# UNITED STATES PATENT AND TRADEMARK OFFICE

APPLICATION NO.	FILING DATE	FIRST NAMED INVENTOR	ATTORNEY DOCKET NO.	CONFIRMATION NO.
10/715,118	11/18/2003	Katsumi Shibayama	046124-5179	2756
9629	7590	08/09/2005	EXAMINER	
MORGAN LEWIS & BOCKIUS LLP 1111 PENNSYLVANIA AVENUE NW WASHINGTON, DC 20004			RAO, SHRINIVAS H	
			ART UNIT	PAPER NUMBER
			2814	
DATE MAILED: 08/09/2005

**Office Action Summary**

***Response to Amendment***

***Fig. 7***

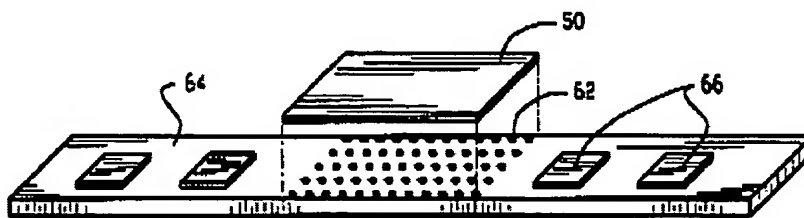
Applicants' first contention that Mattson elements 42/64 are daughter board, ceramic substrate and do not describe a the first conductive type semiconductor substrate having a light-incident surface" features of independent claim 1, is not persuasive because as applicants' agree element 64 is ceramic substrate and as seen from figure 7 ceramic substrate 64 has photodiode 50 thereon .

It not understood how the photodiode 50 will function as a photodiode is light is not incident thereon and the ceramic substrate 64 on which the photodiode 50 is placed.

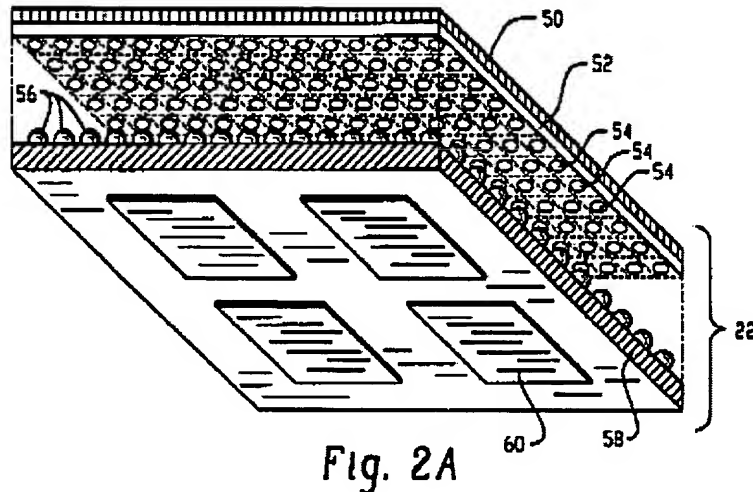
Applicants' second contention that the last 4 lines of the abstract are not relevant is based on a improper understanding of the cited portion because the cited portion is

referred to as showing elements 42/64 to be substrates, which when further gleamed from figure 7 clearly shows substrates 42/64 to be substrate having a light-incident surface, it is further noted that by definition semiconductors are conducting.

Fig. 3

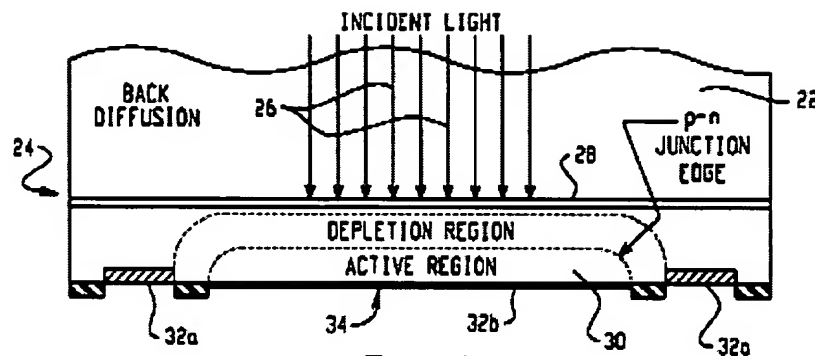
Applicants next contention that Mattason/ Chappo do not describe in particular, the feature recited in independent claim 1 of providing spatially detached regions that constitute pn junctions in a manner that is neither shown nor suggested by Mattson is not persuasive because claim 1 merely recites,"a plurality of second conductive type semiconductor regions spatially detached at each bottom of said recessed portions; wherein said semiconductor regions individually constitute pn junctions together with said semiconductor substrate." And giving the broadest possible interpretation , Mattson figure shows :

It is inherent that a plurality of second conductive type semiconductor regions spatially detached at each bottom of said recessed portions because semiconductor layer having recessed portions will have the remaining portions spatially detached from each bottom of the recessed portions.

Further as shown in figure 3, Mattson shows pn junctions.
